LEXINGTON-FAYETTE URBAN COUNTY GOVERNMENT CONTRACT CHANGE ORDER Page 1 of 2	Date:	November 16, 2015	
	Project:	Senior Citizen Center Construction	
	Location:	Lexington	
To (Contractor): Marrillia Design & Construction 259 West Short Street Suite 325 Lexington, KY 40507	Contract No.	227-2014	
	Original Contract Amt.	\$8,882,900.00	
	Cumulative Amount of Previous Change Orders	\$1,349,994.37	
	Percent Change - Previous Change Orders		15.20%
	Total Contract Amount Prior to this Change Order	\$10,232,894.37	
	Change Order No.	28

PR-53 Cost to Remediate the Subsurface Grades Below the Paving Subgrade at the Life Lane Entry Drive per Proposal Request No. 40 - Revision #1

PROJECT	LFUCG Senior Citizens' Center 201333	DATE SENT	10/27/2015
SUBJECT	Entry Drive Subsurface Remediation	PROPOSAL REQUEST ID	PR-040
TYPE	Proposal Request	TRANSMITTAL ID	00713
PURPOSE	For Review and Response	VIA	Info Exchange

**Subject: Limited Exploration and Pavement Subgrade Recommendations
Lexington Senior Citizens Center – Idle Hour
St. Ann Drive
Lexington, Kentucky**

L10.0

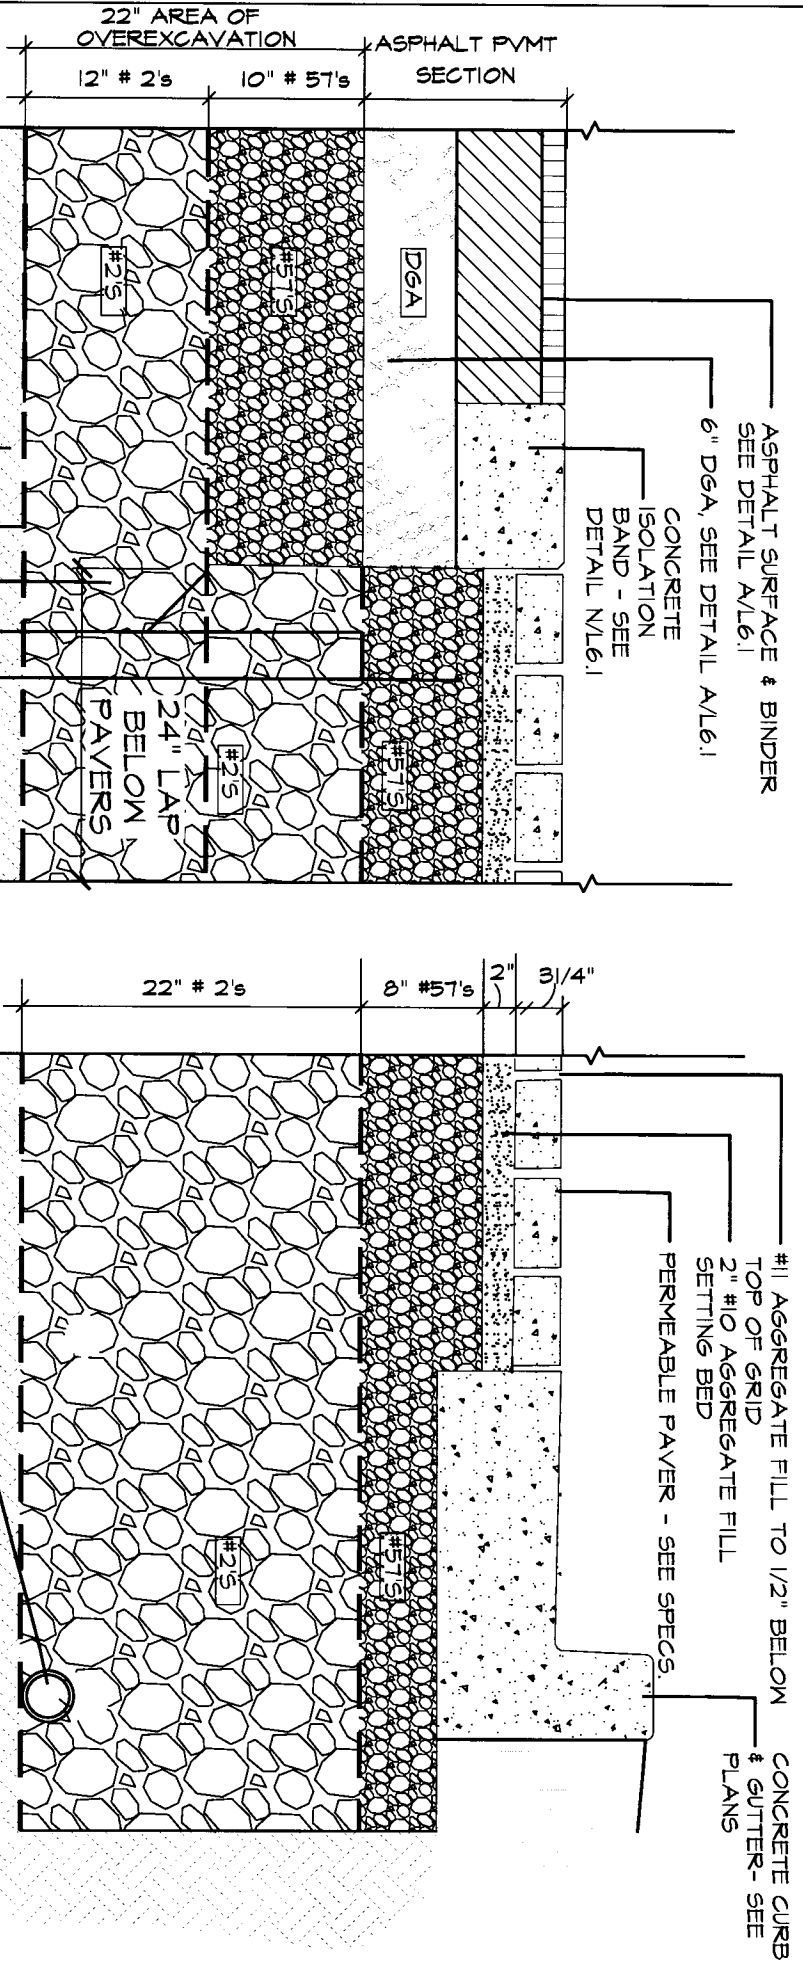
Please provide pricing to remediate the subsurface grades below paving subgrade at the Life Lane entry drive, per recommendations by the geotechnical engineer. Site observation has shown the entire entry drive area designated for heavy duty pavement (per sheet L4.1) is unstable under construction traffic, and the recommendation is as follows:

- undercut below pavement subgrade by 24 inches
- install an 8" perforated pipe at the base of undercut as shown on attached sketch L10.0, drain to structure CI-6
- install stone and geotextile per PR-018 recommendations (similar to those used in main parking areas, see attached sketch)

- install heavy duty asphalt paving (6" DGA, 5 1/2" base course, 1 1/2" surface course) over compacted sub-grade stone per A/L6.1

8' perforated subdrain at low end of overexcavation, in stone backfill. Tie to new curb inlet or existing storm drain.

ENTRANCE DRIVE WORK ADDITIONAL. ADD DATA BASE TO PAVEMENT AS SHOWN. FINISH GRADES SHOWN THERE.
